Sea Link

Document 9.150 Applicant's Comments on Responses to Third Written Questions

Planning Inspectorate Reference: EN020026

Version: A
April 2026

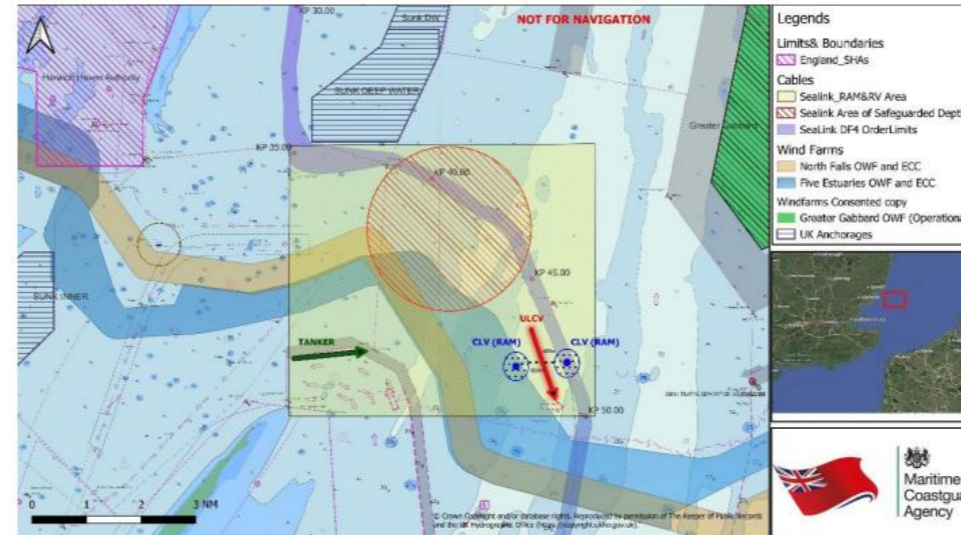
Reference	Question to: Question	Response from Interested Party or Affected Person	Applicant's Comments
e		<p>areas, the Sunk and English Channel, one of the busiest shipping lanes in the world.</p> <p>Also, a recent trend is that, due to the northward migration of the Long Sand bank (within the Sunk area), larger vessels using the Long Sand Head (LSH) two-way route tend increasingly to divert into the Sunk Inner (north of the magenta line marking the northern limit of the LSH route), to maintain safe navigable depth. This behaviour further reduces available sea room particularly when vessels are simultaneously outbound from the PLA and can therefore create additional navigational constraints.</p> <p>A further complication is that, during the summer months, numerous sailing vessels often cut directly across the area on a straight Southeast course from Harwich, right through the area. This reduces available sea room and is made more challenging by the fact that many of these pleasure craft have low-power radios and only carry Category B AIS transponders, making it difficult or sometimes impossible for VTS to detect or communicate with them.</p> <p>Similar issues arise with some fishing vessels, which often switch off their AIS to avoid revealing their location to other fishermen.</p> <p>These additional factors all further constrain the already limited safe sea room, both before and after a vessel has a pilot on board. This risk should not be underestimated, as the operators of such small crafts are frequently unaware of, or do not fully adhere to the Collision Regulations, including the requirement not to impede deep draft vessels in designated deepwater routes.</p> <p>In summary, the MCA requires this defined area of interest to account for a credible worst-case scenario, namely, multiple RAM operations taking place within an already constrained sea area, potentially in restricted visibility, and in proximity to some of the largest vessels operating worldwide. An incident involving an ultra-large vessel, such as one comparable to the Ever Given in the Suez Canal, would have significant safety implications, attract global media attention, and be likely to adversely affect the UK economy. The proposed restriction is therefore both proportionate and essential to ensuring the Safety of Navigation within the Sunk area.</p> <p><u>Section B</u> [see image in IP's submission]</p>	<p>(iii) <i>weather constraints.</i></p> <p>The Applicant considers that this text is sufficient to secure this outline plan, and aligns with other recent DCOs namely Five Estuaries and North Falls.</p>

In the above example, two Cable Laying RAM vessels (blue) are operating in each of the cable corridors (Sealink and Five Estuaries), within the Long Sand Heads two way route: a tanker (green) is outbound using the northern part of the LSH route (allowing for the migrating sandbank), after dropping pilot, the outbound Ultra Large Container Vessel (red), is forced to proceed southbound between the RAM vessels meaning that the resultant distance to the 500m Recommended Restricted Zone is 600m which is only 1.5 times the vessel length (400m LOA) of an ultra large container. The average turning circle of such a vessel is at least 3-4 times the ship length and the stopping distance is approximately 3-5 ships length depending on various factors including draught, windward area, weather and sea conditions. This scenario is not factoring in any additional traffic like another out bound vessel (slower) ahead of the container vessel and recreational vessels crossing through the precautionary area in a SE direction, this will further complicate this scenario and may result in multiple close quarter situations within the precautionary area.
